SAFETY RECALL CODE 0825 - SIDESTAND LEG FOR 2003 FIREBOLT XB9R

Purpose

As recently advised in BML-023, Buell Distribution Company, LLC has decided that there is a safety defect with the side-stand legs on certain 2003 XB9R motorcycles which causes them to have the potential to bend or break without notice, thereby allowing the motorcycle to fall and potentially cause an injury.

Figure 1. Correct Sidestand with Footpad Stamped

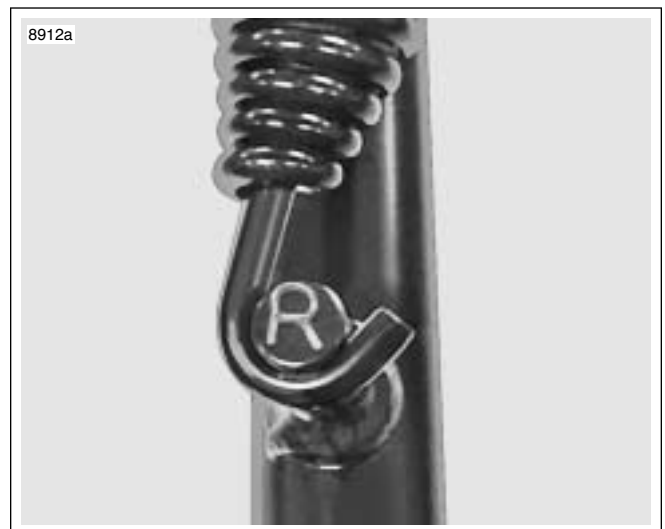
See [Figure 1](#). The correct replacement sidestand, for the purpose of this bulletin, is: Part No. 94129Y. It can be identified by the Letter "R" stamped on either the sidestand footpad or on the sidestand leg pin. See [Figure 2](#).

Figure 3. Sidestand Assembly

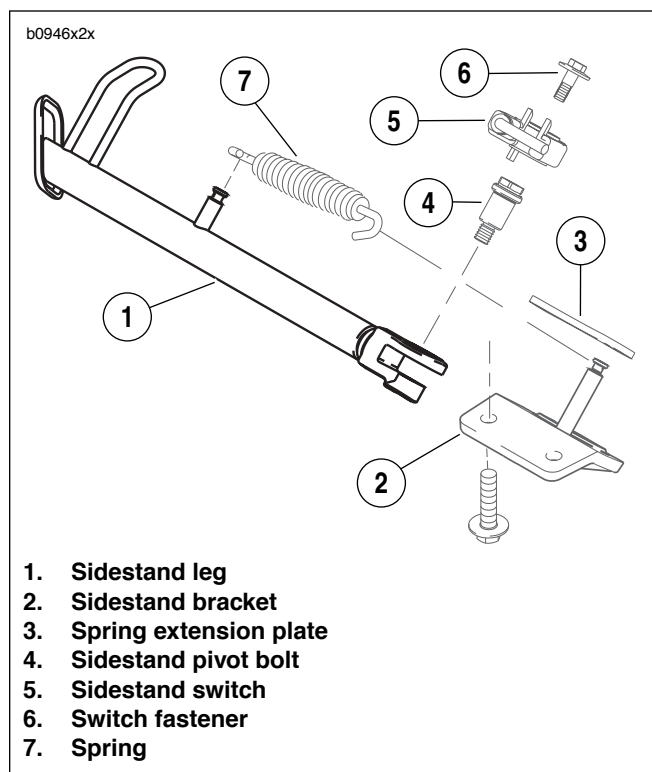
2. See [Figure 3](#). Remove sidestand switch (5).
 - a. Retract sidestand leg (1).
 - b. Remove switch fastener (6).
 - c. Extend sidestand leg.
 - d. Lift sidestand switch and slide to the right away from spring post on sidestand bracket (2) and leave attached to harness.
3. Remove sidestand leg (1).
 - a. Retract sidestand leg.
 - b. Remove sidestand spring (7) and spring extension plate (3) using SNAP-ON SPRING TOOL (Part No. HE-52B).
 - c. Remove sidestand pivot bolt (4).
 - d. Extend sidestand leg and remove.

- c. See [Figure 3](#). Install sidestand (1) and sidestand pivot bolt (4) tightening to 18-20 ft-lbs (24-27 Nm).
- d. Retract sidestand leg.
- e. Install spring extension plate (3) and sidestand spring (7) using SNAP-ON SPRING TOOL (Part No. HE-52B).

Figure 4. Lubricating Points (Shaded Areas)

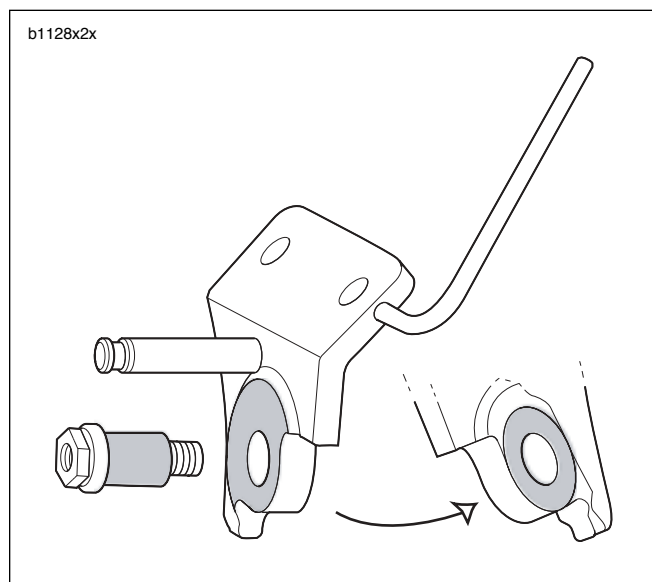
1. Install sidestand leg (1).
 - a. See [Figure 4](#). Lubricate sidestand pivot bolt and mating portions on sidestand bracket with WHEEL BEARING GREASE (Part No. 99855-89).
 - b. See [Figure 5](#). Apply LOCTITE 272 (Red) to threaded area (clevis) of sidestand leg.

Figure 5. Threaded Area for Loctite Application

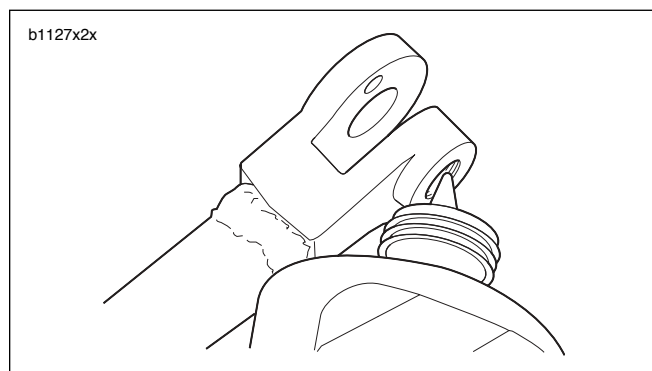
Applying LOCTITE to threaded area of clevis on sidestand leg, instead of threads on the pivot bolt, will eliminate build-up between clevis and sidestand bracket which can interfere with the applied lubricant.
